SPENT FUEL WORKING GROUP REPORT

INVENTORY AND STORAGE OF THE DEPARTMENT'S SPENT NUCLEAR FUEL *and other* REACTOR IRRADIATED NUCLEAR MATERIALS AND THEIR ENVIRONMENTAL, SAFETY AND HEALTH VULNERABILITIES

VOLUME II NOVEMBER 1993 U.S. Department of Energy

HANFORD WGAT

Figure 5

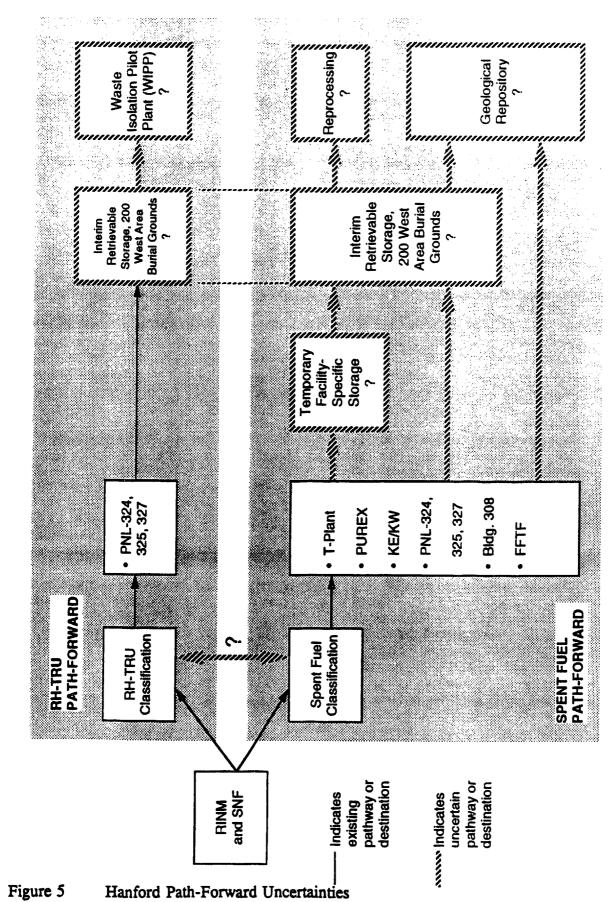
At Hanford, the path-forward for the ultimate disposition or disposal of spent nuclear fuel and reactor irradiated nuclear material is uncertain. Figure 5 shows a simple diagram depicting possible flow paths for these materials. A brief discussion of Figure 5 concerns are provided below:

- Two examples of basic types of RINM include: 1) RH-TRU (fuel pieces or test specimens stored in hot cells or the 200 West Area Burial Grounds); and 2) SNF (e.g., fuels from N-Reactor, Single Pass Reactors, and some commercial reactors stored as spent fuel).
- There is an underlying assumption at Hanford that RH-TRU can be placed in interim retrievable storage and ultimately shipped to the Waste Isolation Pilot Plant (WIPP). This is depicted by the top flow path in Figure 5. However, this pathforward is not guaranteed, because appropriate shipping containers and the WIPP itself are not yet available.

• Another assumption is that spent fuel can be stored in existing locations and ultimately shipped to a geological repository, e.g., Yucca Mountain. This is depicted at the bottom of Figure 5. However, this pathforward is not guaranteed, because appropriate shipping containers and a geological repository are not yet available. In the
